Department of Public Works  
**Engineering Division**  
Robert F. Phillips, P.E., City Engineer  
City-County Building, Room 115  
210 Martin Luther King, Jr. Boulevard  
Madison, Wisconsin 53703  
Phone: (608) 266-4751  
Fax: (608) 264-9275  
[engineering@cityofmadison.com](mailto:engineering@cityofmadison.com)  
[www.cityofmadison.com/engineering](http://www.cityofmadison.com/engineering)

NOTICE OF ADDENDUM  
ADDENDUM NO. 2  
CONTRACT NO. 8498  
ROCKSTREAM DRIVE ASSESSMENT DISTRICT – 2020

**TYPICAL SECTION  
ROCKSTREAM DRIVE  
STA 100+43.31 TO STA 116+58.18**

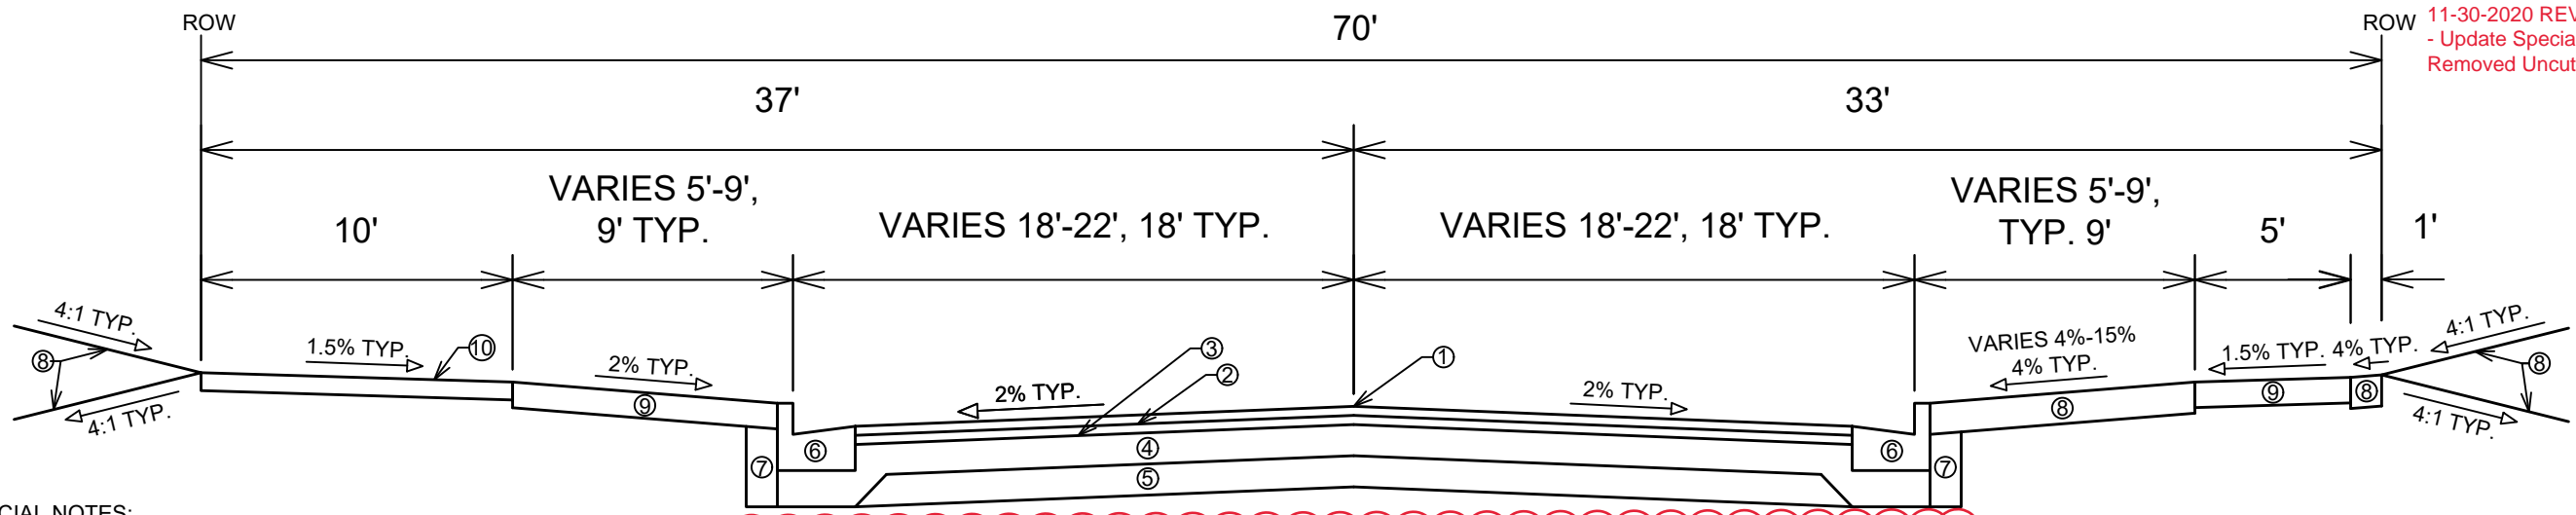
D-1: Update special notes.

11-30-2020 REVISION AJZ  
 - Update Special Notes &  
 Removed Uncut Information

- ROCKSTREAM DRIVE SUBGRADE CONSTRUCTION BETWEEN STA 106+25.00 TO STA 113+25.00 PLACED BY OTHERS. AS PART OF THIS CONTRACT, THE CONTRACTOR SHALL RESHAPE SELECT FILL PLACED BY OTHERS.

- TOPSOIL REMOVAL COMPLETE (STA 106+25 TO STA 122+79.54) BY OTHERS.

- IF LOOSE SANDS ARE DISCOVERED BENEATH THE TOPSOIL, VIBRATORY COMPACTIVE EFFORT/DENSIFICATION AND SUBSEQUENT EVALUATION SHALL BE REQUIRED FOR STABILITY PRIOR TO PLACING SELECT FILL.

\*STA 100+46.08 - STA 106+25.00 SELECT FILL SHALL BE COMPLETED PER ARTICLE 202(c). REPRESENTATIVE SAMPLES OF PROPOSED FILL SHALL BE SUBMITTED TO THE CITY'S GEOTECH CONSULTANT FOR OPTIMUM MOISTURE-MAXIMUM DENSITY DETERMINATION (ASTM D1557) PRIOR TO THE START OF FILL PLACEMENT. THE SAMPLE SIZE SHALL BE APPROXIMATELY 50 LB. THE CITY'S GEOTECH CONSULTANT SHALL BE RETAINED TO PERFORM FIELD DENSITY TEST TO DETERMINE THE LEVEL OF COMPACTION BEING ACHIEVED IN THE FILL. THE TESTS SHALL GENERALLY BE CONDUCTED ON EACH LIFT AT THE BEGINNING OF FILL PLACEMENT AND AT A FREQUENCY MUTUALLY AGREED UPON BY THE PROJECT TEAM FOR THE REMAINDER OF THE PROJECT. STA 106+25 - STA 113+25 SELECT FILL PLACED AS PART OF CITY CONSTRUCTION CONTRACT #8402 BY OTHERS, SEE RESHAPING SELECT FILL SPECIAL BID ITEM.

\*\*TEST ROLLING (STA 100+46.08 - STA 106+25.00) SHALL BE COMPLETED PER ARTICLE 201.29(c) OF THE STANDARD SPECIFICATIONS.

\*\*\*GEOSYNTHETIC REINFORCEMENT FABRIC SHALL BE MIRIAFI RS580i OR AN APPROVED EQUAL. THE BREAKER RUN SHALL BE PLACED DIRECTLY OVER THE FABRIC.

12694  
 D-2

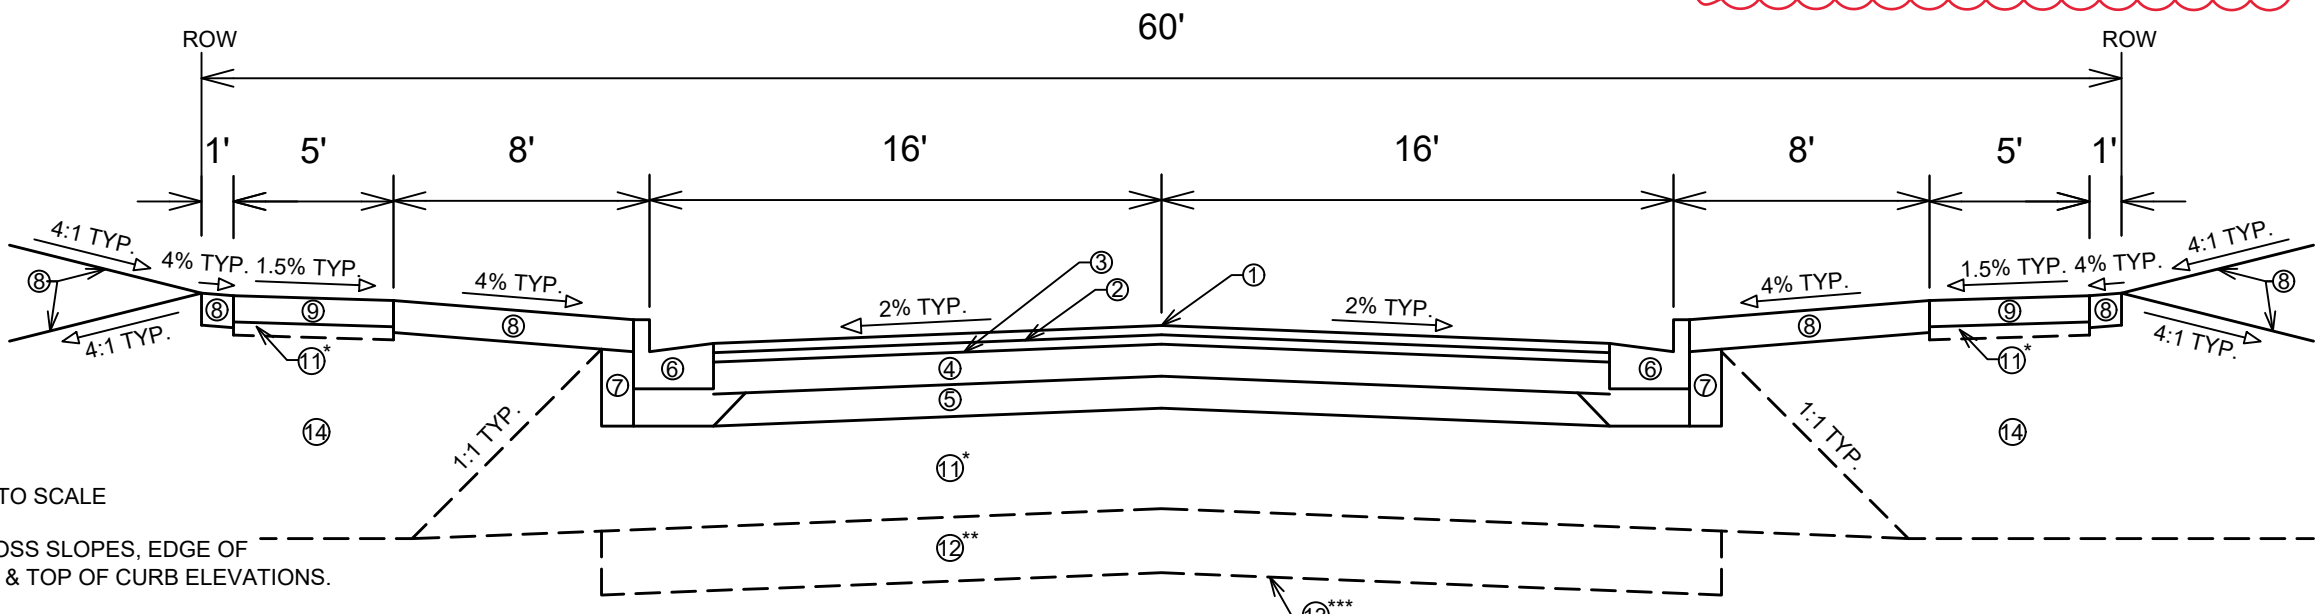
D-2: Update special notes and remove uncut information on Rockstream STA 116+58.18 to STA 122+79.54.

- TYPICAL SECTION NOT TO SCALE
- SEE X-SHEETS FOR CROSS SLOPES, EDGE OF PAVEMENT ELEVATIONS, & TOP OF CURB ELEVATIONS.
- TOPSOIL REMOVAL COMPLETE (STA 106+25 TO STA 122+79.54) BY OTHERS.

- TYPICAL SECTION NOT TO SCALE
- SEE X-SHEETS FOR CROSS SLOPES, EDGE OF PAVEMENT ELEVATIONS, & TOP OF CURB ELEVATIONS.
- IF LOOSE SANDS ARE DISCOVERED BENEATH THE TOPSOIL, VIBRATORY COMPACTIVE EFFORT/DENSIFICATION AND SUBSEQUENT EVALUATION SHALL BE REQUIRED FOR STABILITY PRIOR TO PLACING SELECT FILL.

ROCKSTREAM DRIVE PROJECT NO. 12694	SHEET NO. U-9
STORM SEWER SCHEDULE	
CITY OF MADISON

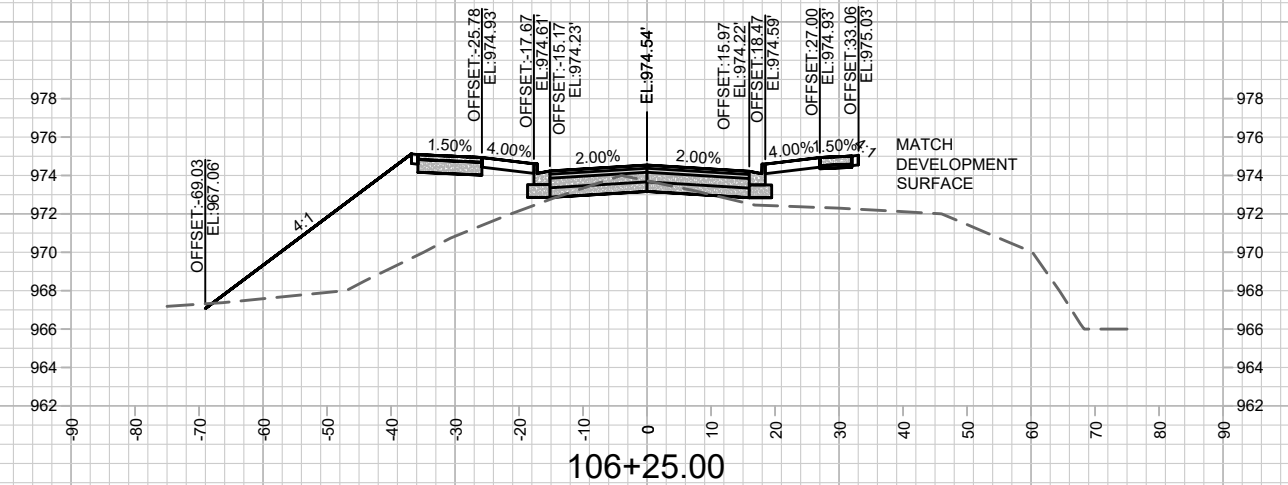
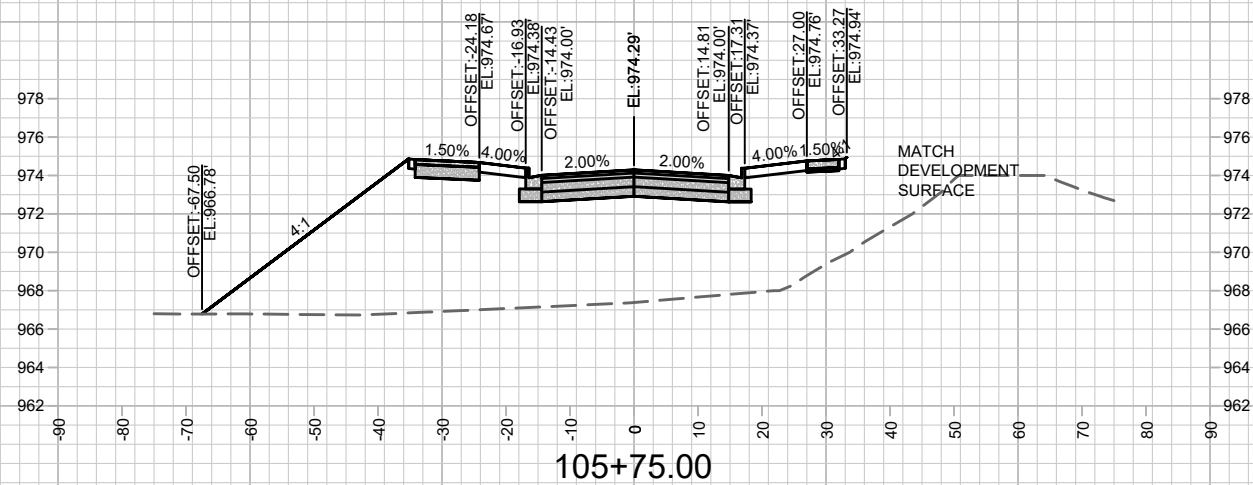
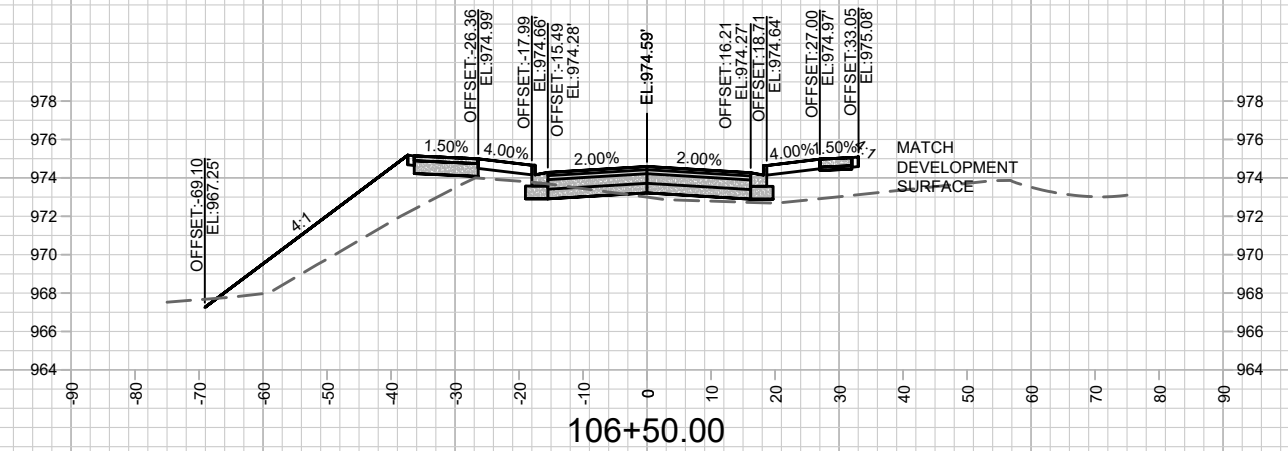
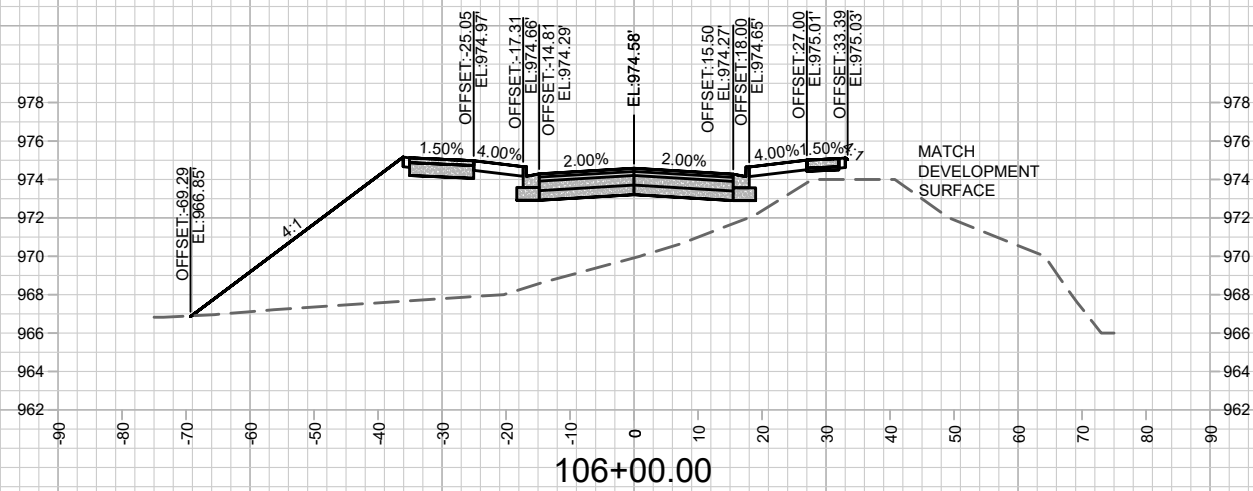
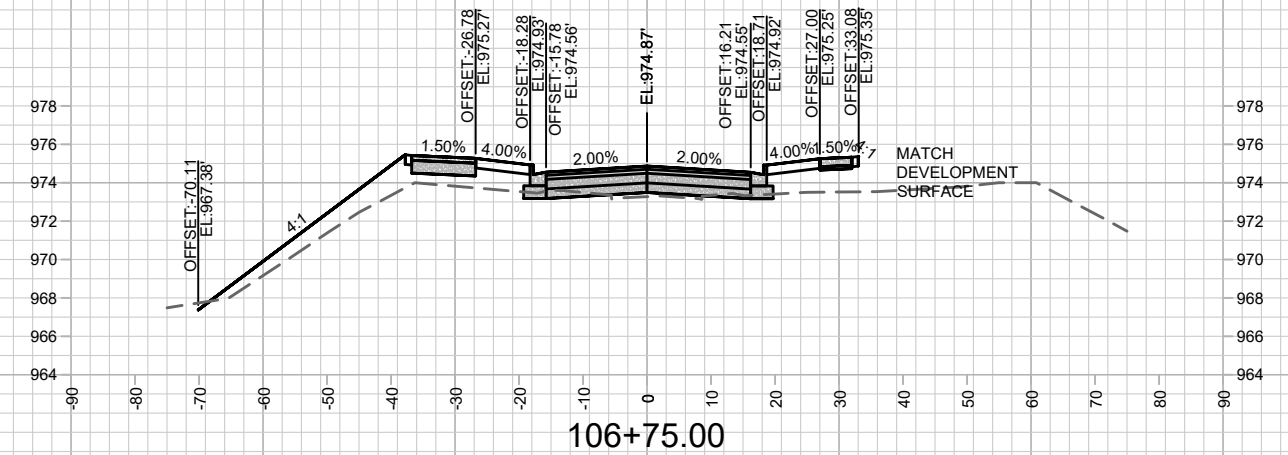
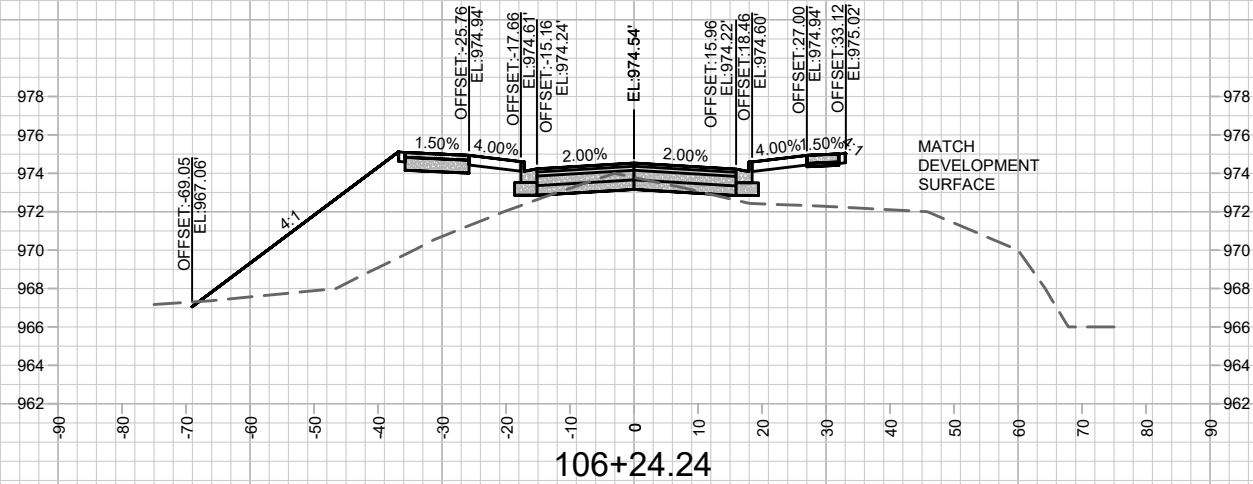
U-9: Revised note for structure S6-A in storm schedule.

\*REVISED 11/19/2020: TERRACE INLET NOTES REVISED

12694  
 X-5

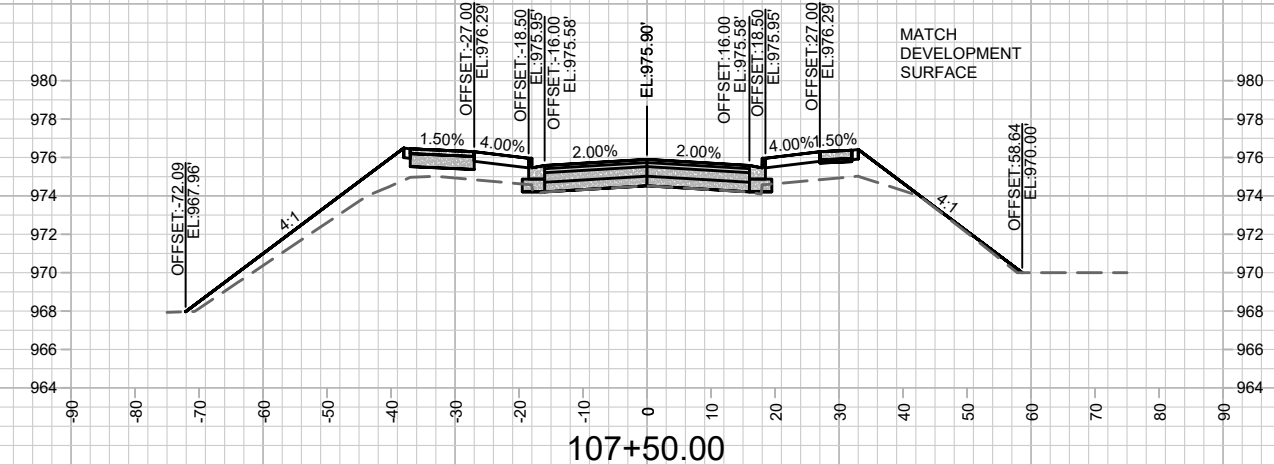
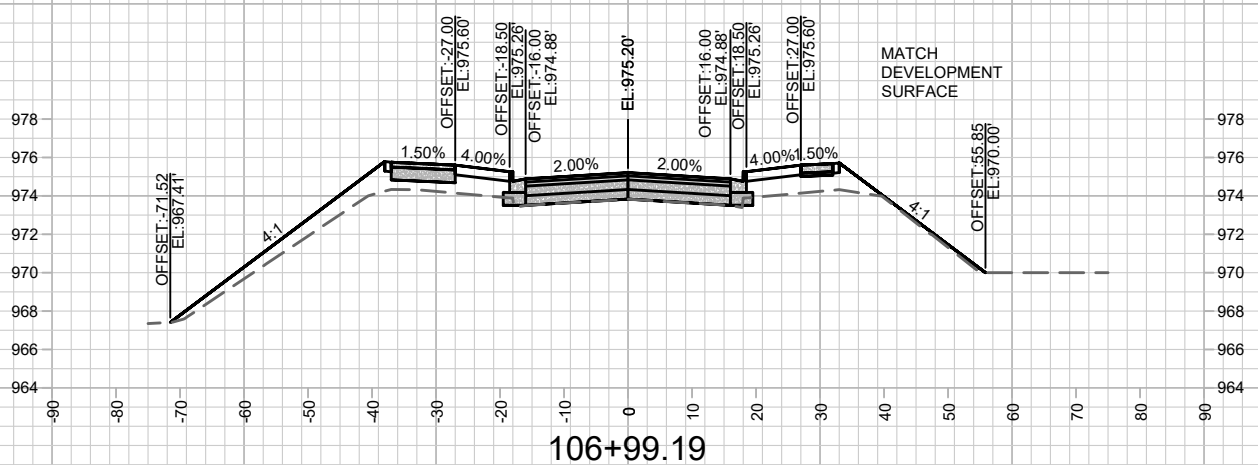
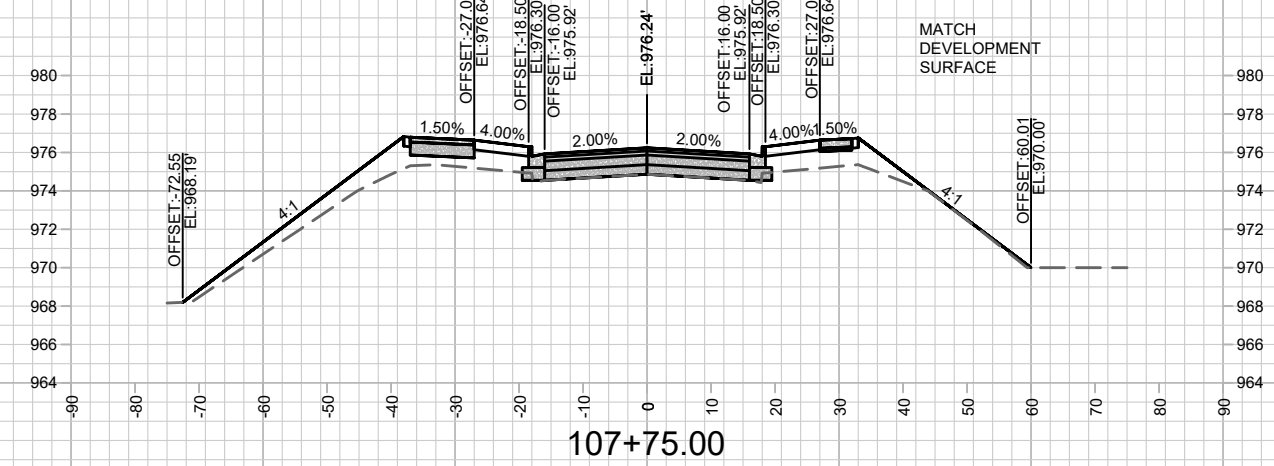
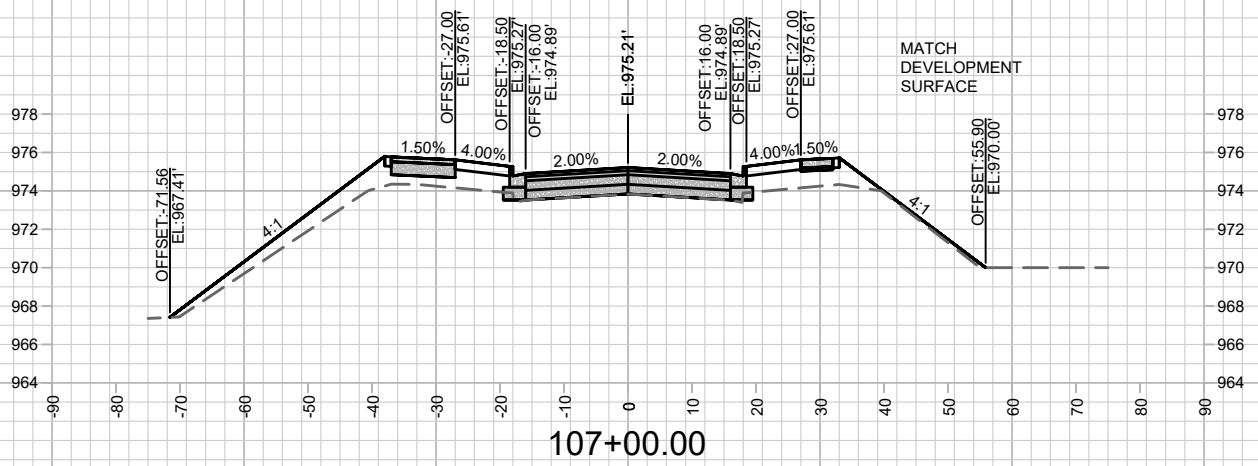
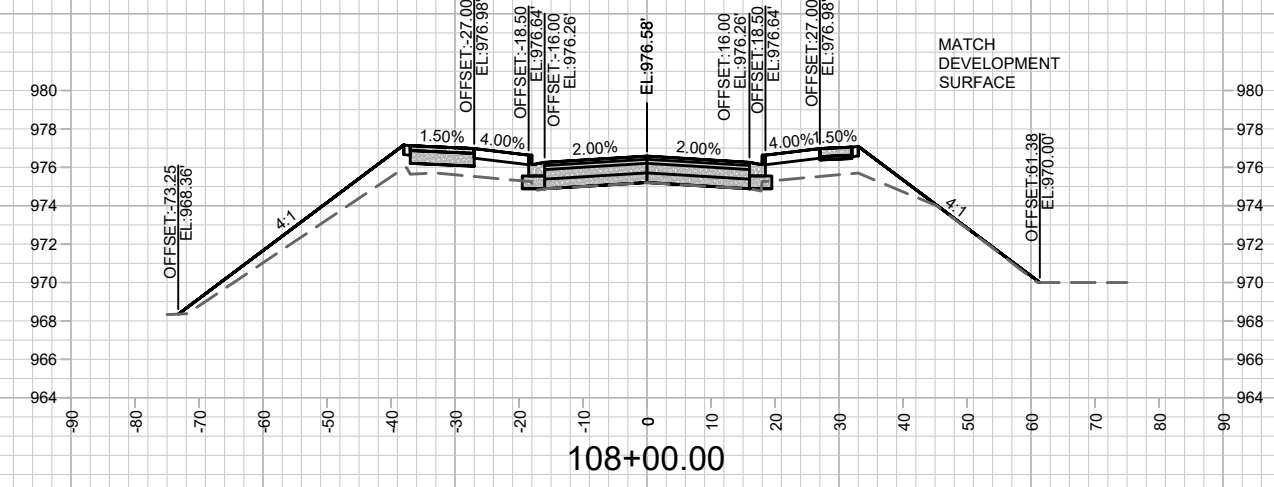
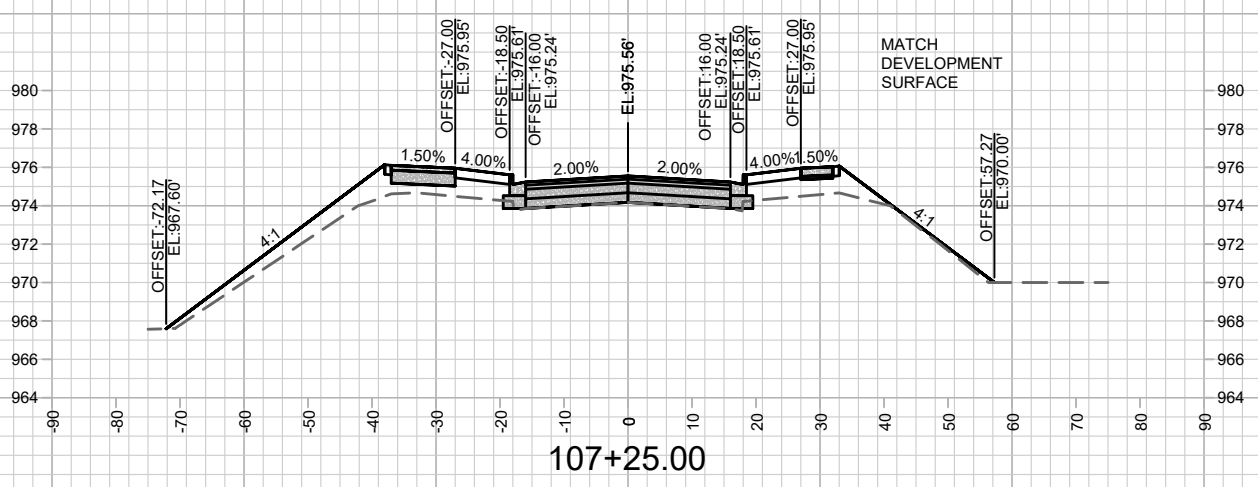
X-5 – X17: Update existing surface to reflect current site conditions.

11-30-2020 REVISION AJZ  
 - Updated Existing Surface
